UNITED STATES PATENT AND TRADEMARK OFFICE

APPLICATION NO.	FILING DATE	FIRST NAMED INVENTOR	ATTORNEY DOCKET NO.	CONFIRMATION NO.
10/530,225	12/05/2005	Jarmo Smahl	13162-016US1 2021973US	8066
26161 7590 01/28/2008 FISH & RICHARDSON PC P.O. BOX 1022 MINNEAPOLIS, MN 55440-1022			EXAMINER KEE, FANNIE C	
			ART UNIT 3679	PAPER NUMBER
			MAIL DATE 01/28/2008	DELIVERY MODE PAPER

Office Action Summary	Application No.	Applicant(s)	
	10/530,225	SMAHL, JARMO	
	Examiner	Art Unit	
	FANNIE C. KEE	3679

DETAILED ACTION

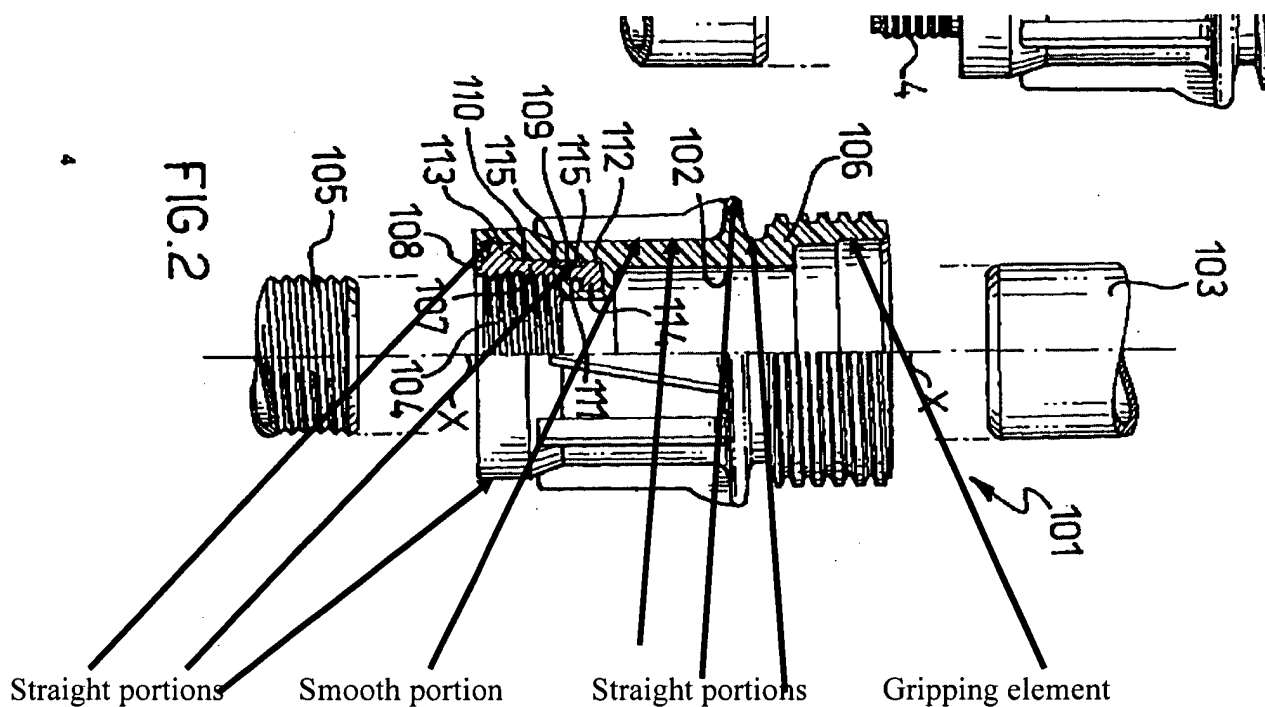
With regard to claim 1, and as best understood by Examiner, Mazzacano et al disclose a connecting piece (101), intended for connecting at least two elements, whereby a first element (105) is connected to a first end of the connecting piece and a second element (103) is connected to a second end of the connecting piece, the connecting piece being comprising a body (106)

mainly of plastic, at least one end of the connecting piece a metal insert (108) provided with a thread (104), whereby at least one element is connectable to the connecting piece with threaded connection and at least one gripping element on the outer surface of the connecting piece for rotating the connecting piece or keeping it still upon making the threaded connection, that the gripping element comprises at least two straight portions such that two straight portions on opposite sides of the connecting piece are parallel, the straight portions forming gripping surfaces for a tool, and a portion which is arranged smooth between adjacent straight portions, whereby the gripping element is formed such that the tool round the gripping element slips before the thread and/or the basic structure of the connecting piece gets damaged (see Figure 2 below).

With regard to claim 2, and as best understood by Examiner, Mazzacano et al disclose the gripping element comprising six straight portions (see Figure 2 above).

With regard to claim 3, and as best understood by Examiner, Mazzacano et al disclose the gripping element being formed of two or more ribs in the direction of the periphery of the connecting piece (see Figure 2 above).

With regard to claim 4, and as best understood by Examiner, Mazzacano et al disclose the outer surface of the metal insert being provided with ribs (113, 114) in the direction of the periphery, the ribs of the metal insert and the ribs on the outer surface of the connecting piece being arranged at the same point (see Figure 2).

With regard to claim 5, and as best understood by Examiner, Mazzacano et al disclose the portion which is arranged smooth being a rounded portion (see Figure 2 above).

With regard to claim 6, and as best understood by Examiner, Mazzacano et al disclose a connecting piece (101), intended for connecting at least two elements, whereby a first element (105) is connected to a first end of the connecting piece and a second element (103) is connected to a second end of the connecting piece, the connecting piece comprising a body (106), at least one end of the connecting piece a thread (104), whereby at least one element is connectable to the connecting piece with threaded connection and at least one gripping element on the outer surface of the connecting piece for rotating the connecting piece or keeping it still upon making the threaded connection, the gripping element comprising at least two straight portions such that two straight portions on opposite sides of the connecting piece are parallel, the straight portions forming gripping surfaces for a tool and a portion which is arranged smooth between adjacent straight portions, whereby the gripping element is formed such that the tool round the gripping element slips before the thread of the connecting piece gets damaged (see Figure 2 above).

With regard to claim 7, and as best understood by Examiner, Mazzacano et al disclose the gripping element comprising six straight portions (see Figure 2 above).

With regard to claim 8, and as best understood by Examiner, Mazzacano et al disclose the gripping element being formed of two or more ribs in the direction of the periphery of the connecting piece (see Figure 2 above).

With regard to claim 9, and as best understood by Examiner, Mazzacano et al disclose the portion which is arranged smooth being a rounded portion (see Figure 2 above).
